**SUBMISSION ON THE IMO'S DRAFT MRCP REPORT FOR 2014-15 CAPACITY YEAR**

Merredin Energy is a new participant in the South West Interconnected System and owner of the 82MW peaking generation plant being constructed near the town of Merredin, WA. We welcome the opportunity to provide comments on the Independent Market Operator's Draft Report on the Maximum Reserve Capacity Price published on 13 December 2011. Our submission on the MRCP for 2014-15 is attached.

## SUBMISSION ON THE IMO'S DRAFT MRCP REPORT FOR 2014-15 CAPACITY YEAR

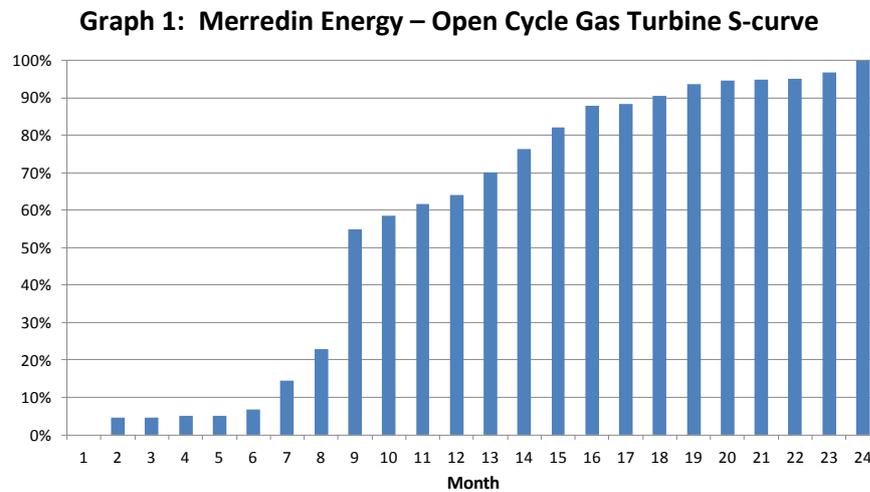
The following graph for the Merredin Energy 82MW Power Plant (currently in month 18 of its construction phase) clearly shows that over 50% of the total project costs were spent in the first nine months of the project.

Merredin Energy previously suggested a 14 month gross up period be used rather than the proposed six months for the timeframe of the WACC. The graph above shows that it is completely unrealistic to assume no money spent in the first 12 months of a project. In deriving a six month period, PwC assumed a 12 month construction spend period, with construction completed the same day that capacity revenues commence. Prudent planning and construction timetables include buffers for testing periods and appropriate delay contingencies. Our view is that the six month period should be increased. The current WACC gross-up calculation also fails to recognise that equity is fully exposed to risks during the 24 month construction and commissioning period. Because equity is exposed during that full two year period, it should earn a risk premium for that entire period. Based on a 14 month average spend period, the true cost of capital during the two year development phase is:

$$(1 + \text{WACC})^{14/12} \times (1 + \text{WACC} - \text{risk free})^{10/12}$$

An adjustment to the capital raising costs within Margin (M) should be made to correct for this anomaly.
